**RIO GRANDE RESERVOIR
2017 PROPOSED WORK
DOWNSTREAM ACCESS ROAD**

INTRODUCTION

San Luis Valley Irrigation District (SLVID) plans to construct the new access road to the downstream toe of the dam in September and October 2017. The new road would be built at a maximum of 10 percent grade and 20 feet wide. This would replace the existing narrow road with grades as steep as 19 percent. The new road will allow delivery of materials (pipe, valves, and concrete) by truck for the ultimate rehabilitation project.

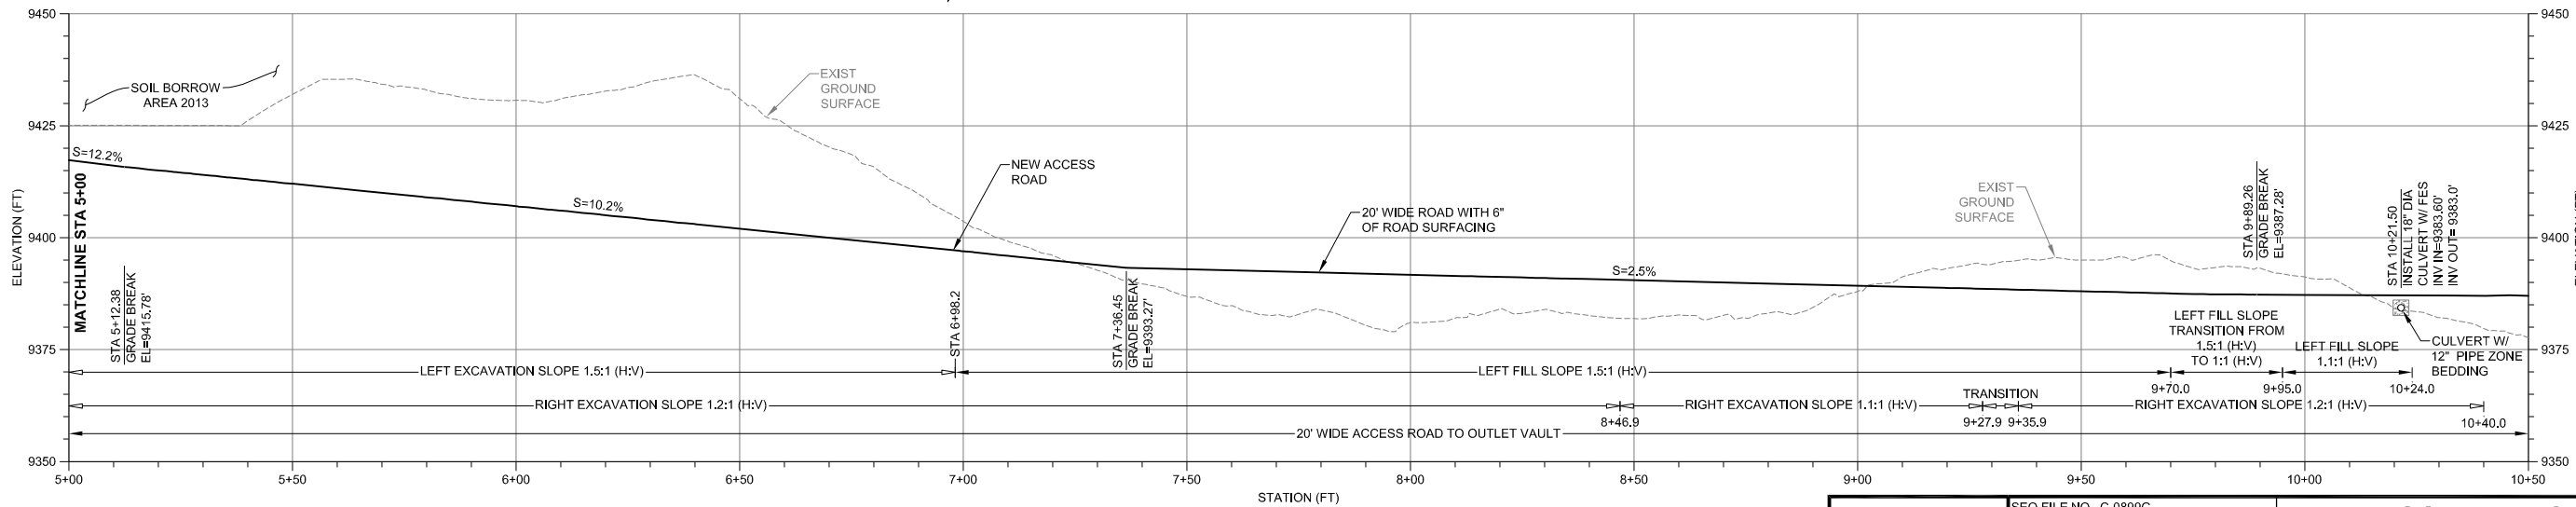
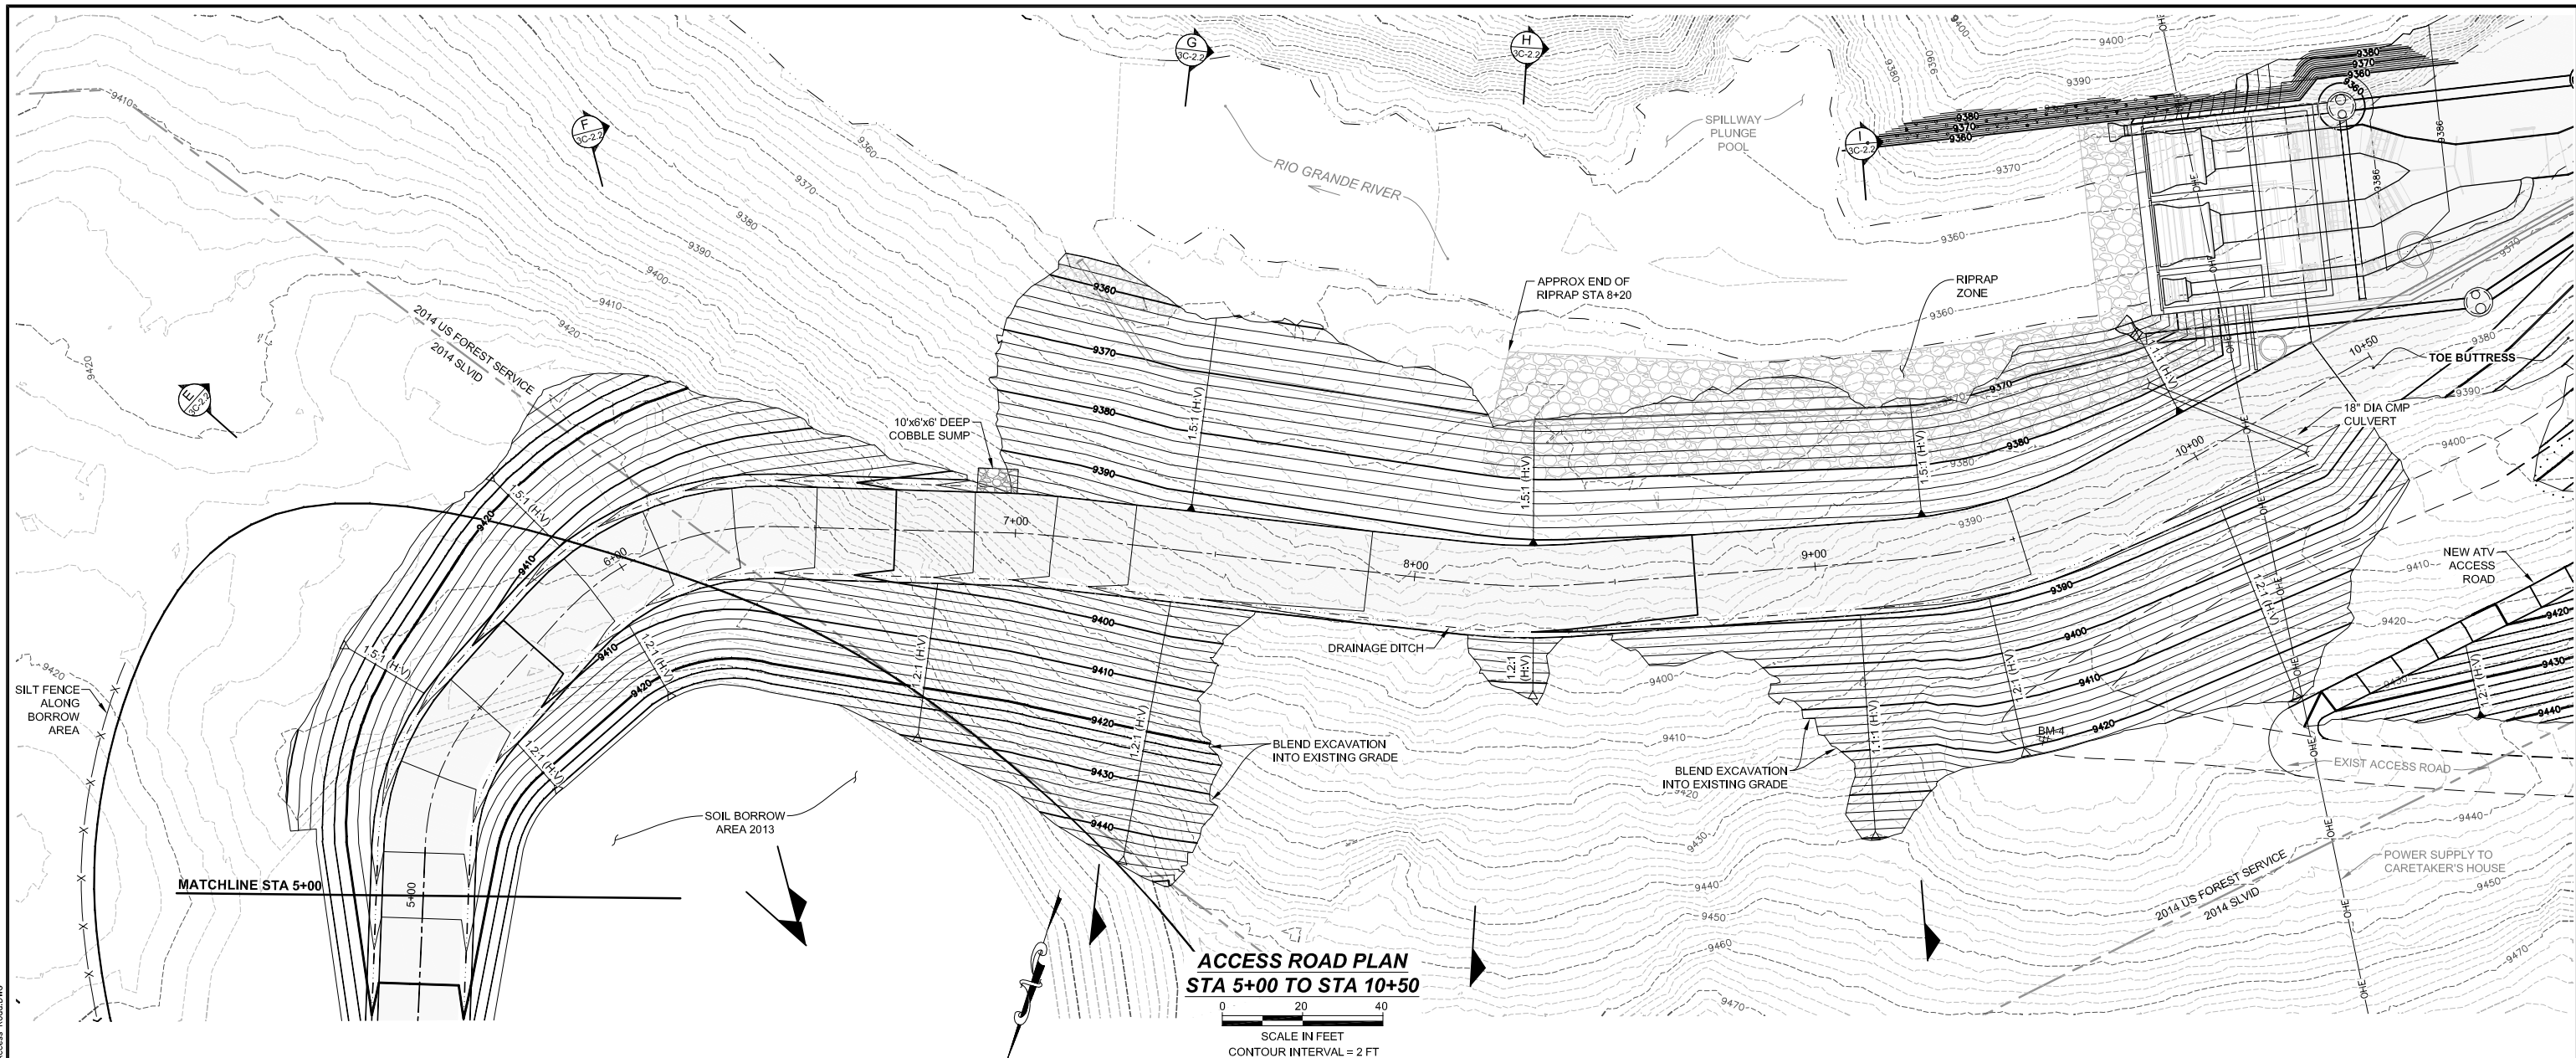
The final proposed work is shown on the four attached plan sheets. The work would be built as shown on the plans up to station 7+40. From station 7+40 to station 10+50, the road grade would be lowered from plan to get to the existing river level.

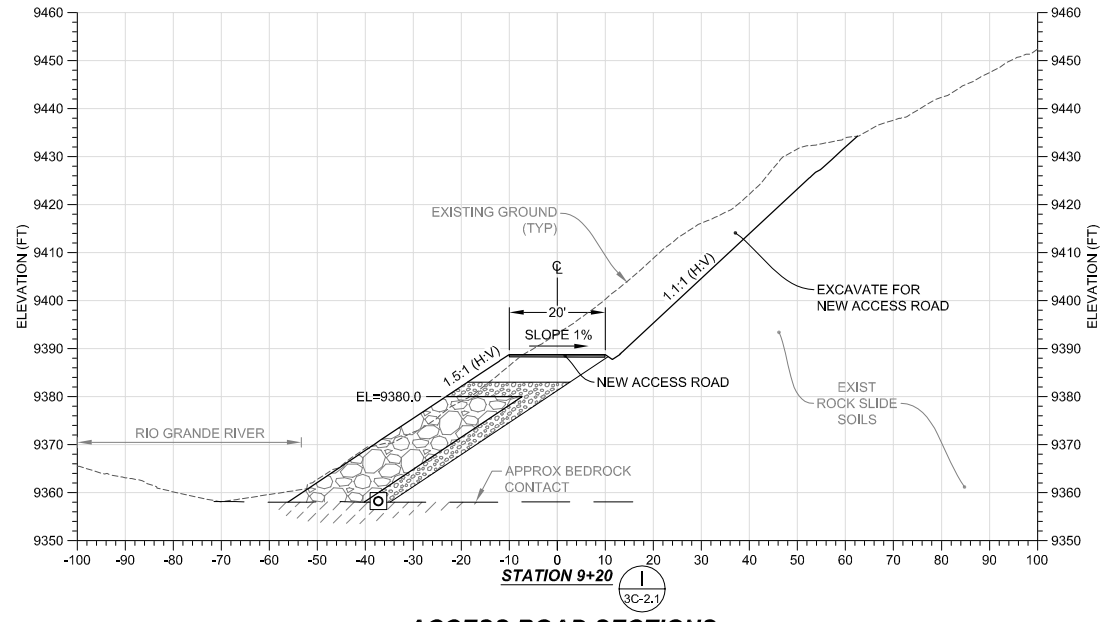
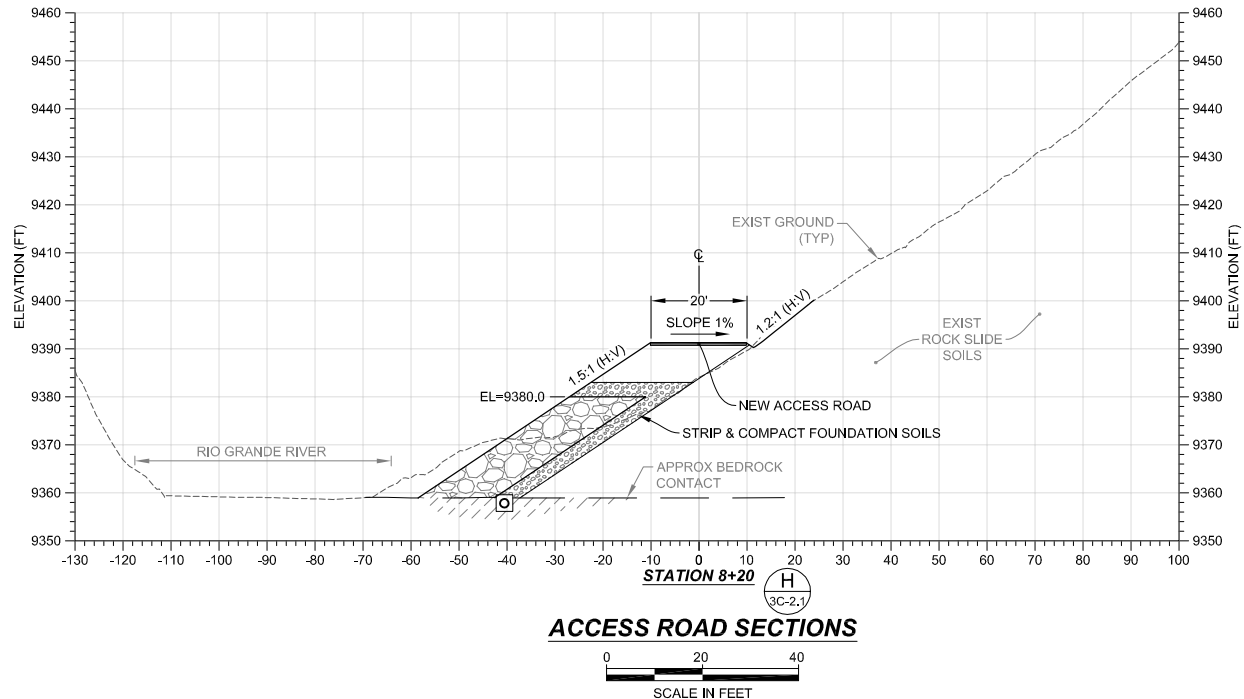
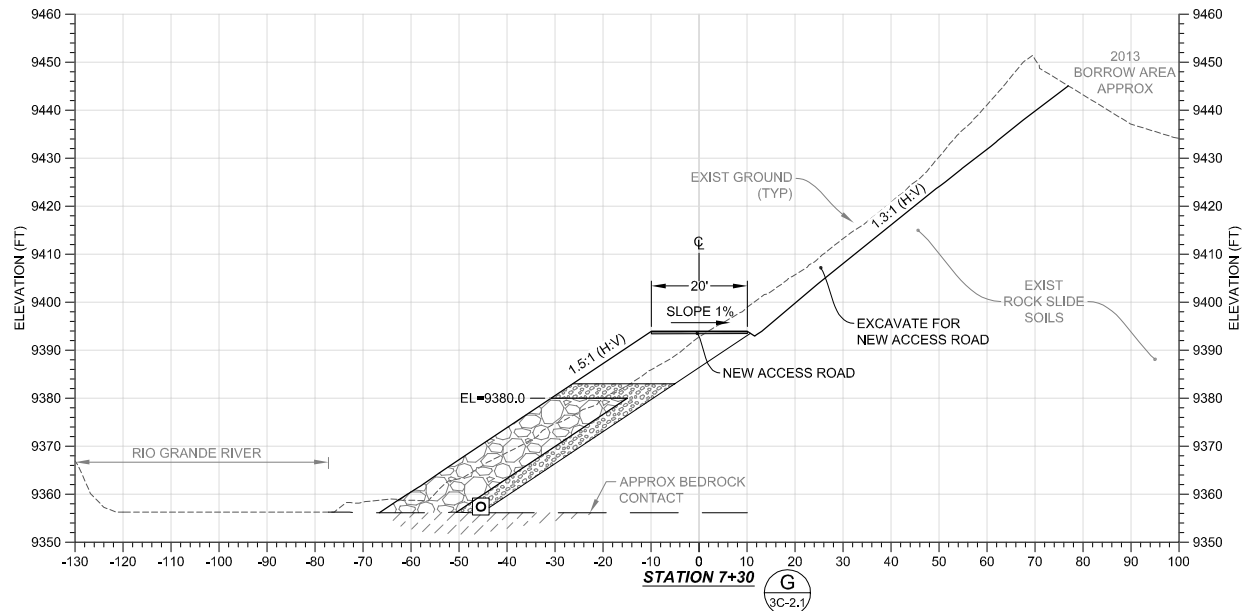
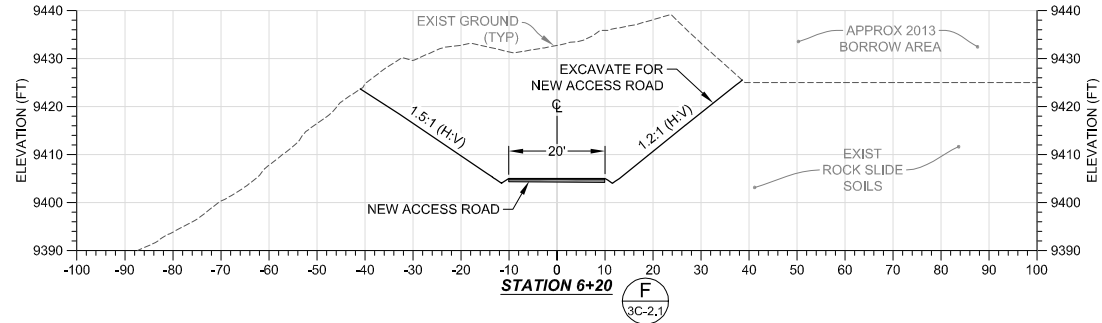
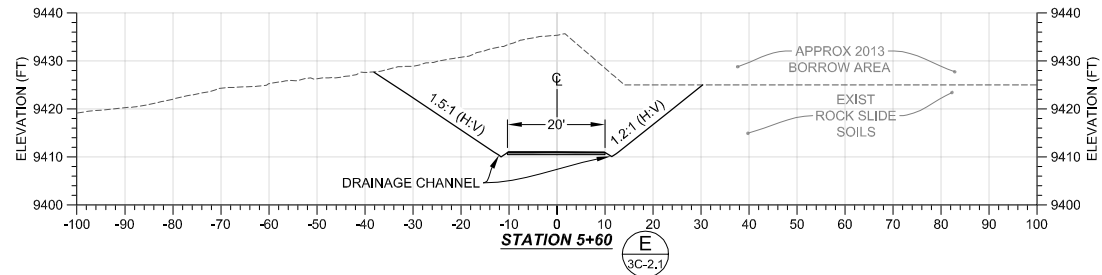
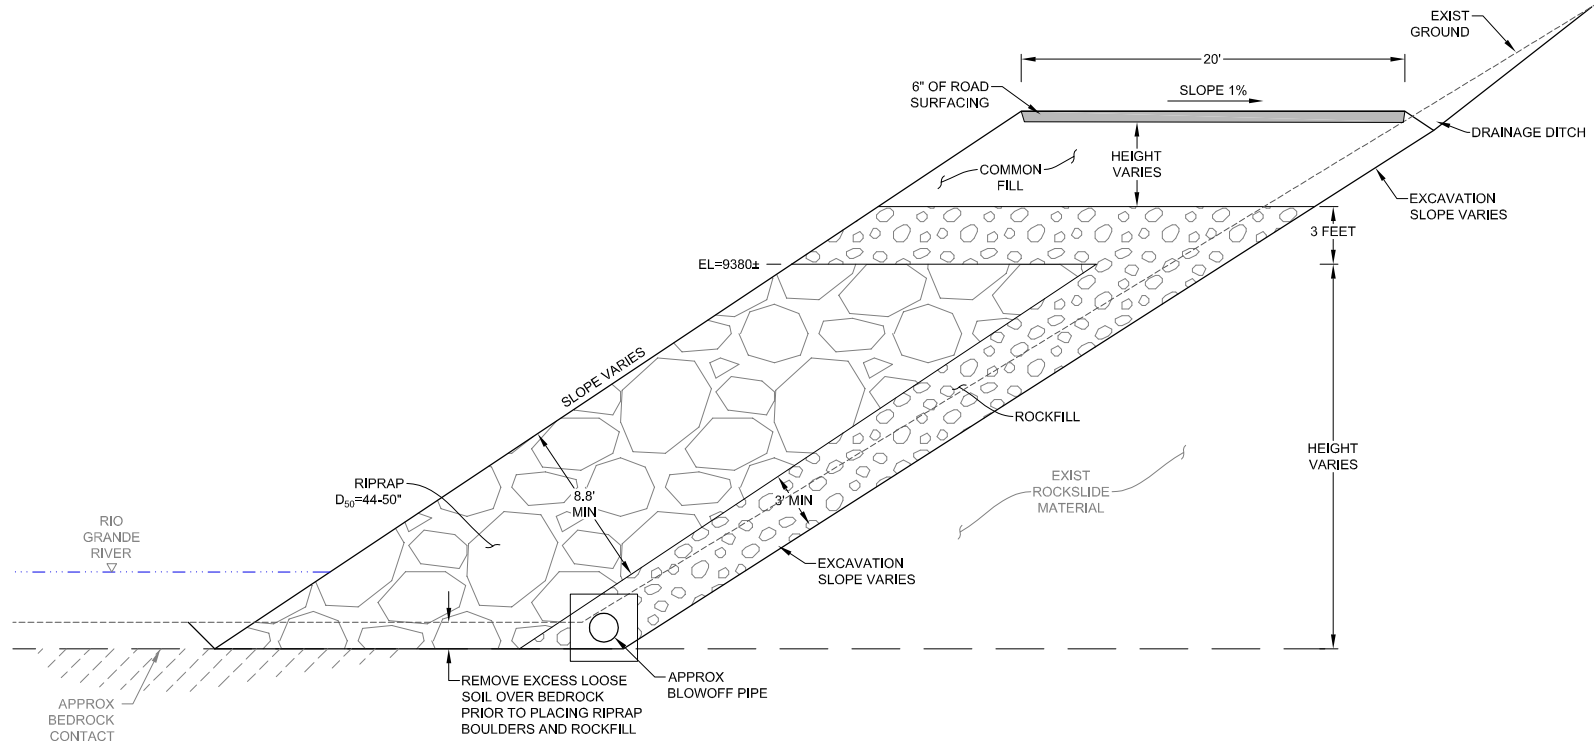
The left bank of the river would be armored with very large riprap as shown on sheet 3C-2.2 with the access road built to about elevation 9380 feet.
